SERVICE BULLETIN

71

INSPECTION OF RUDDER PEDAL LAYSHAFT MOUNTING BRACKETS

T67M260-T3A and T67M260 Pre Mod M720 Aircraft.

Fig 1
RUDDER PEDAL MECHANISM

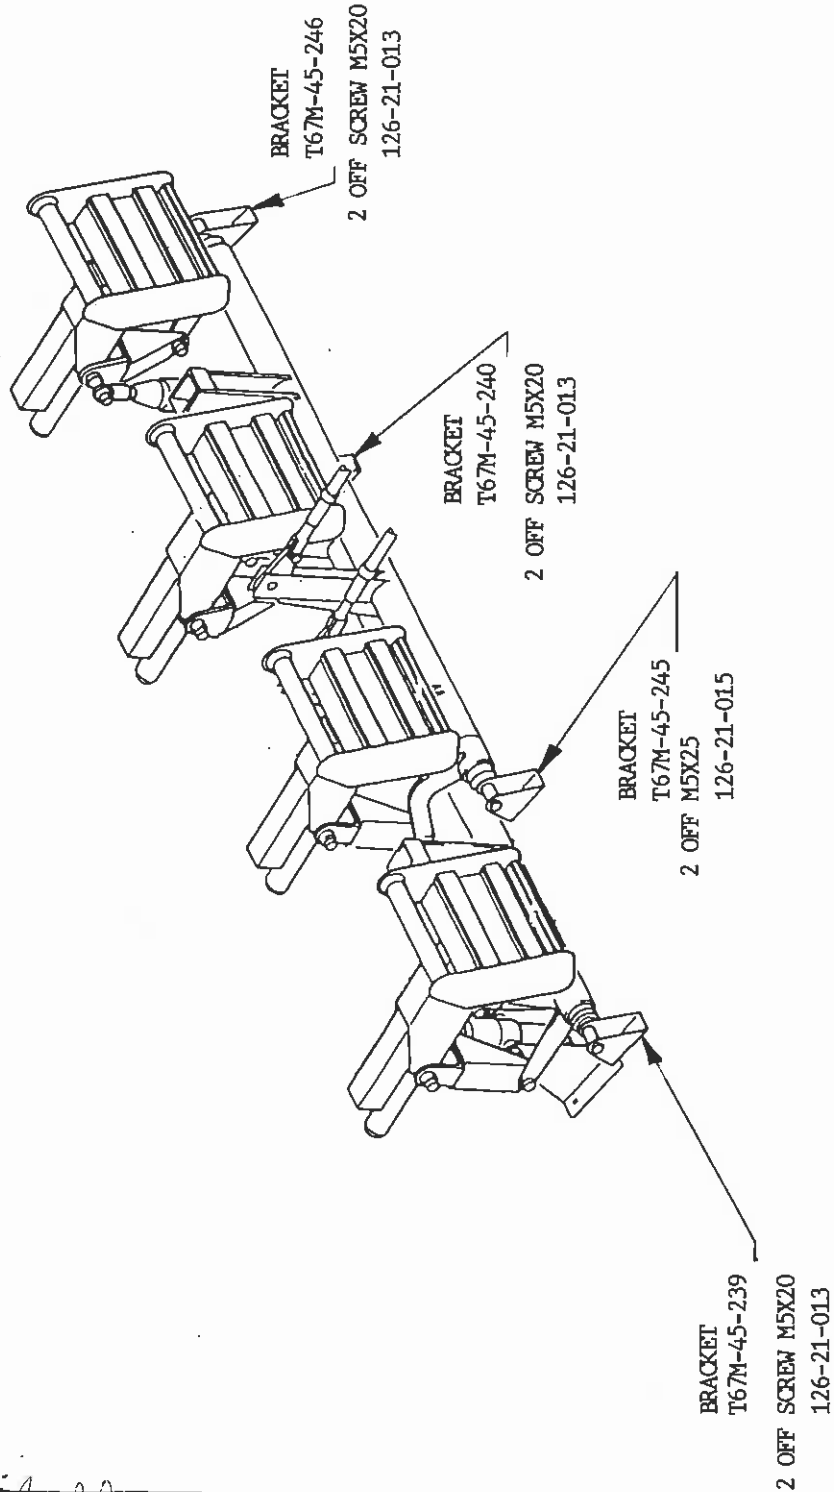
It has been reported that on a few aircraft the rudder pedal bar support bracket screws are loose requiring one to two turns to tighten.

1. Gain access to brackets ref. Fig. 1.
2. Check mounting fasteners for security (2 off per bracket), screw in any loose fasteners.
3. Tighten all fasteners to torque value of 58 lbf in (6.5 Nm).
4. Reassemble aircraft ref Action 1.
5. Annotate in Log Book SB 71 Issue 2 carried out.
6. Actions 2 to 5 to be repeated every 150 hr intervals until Mod M720 incorporated.
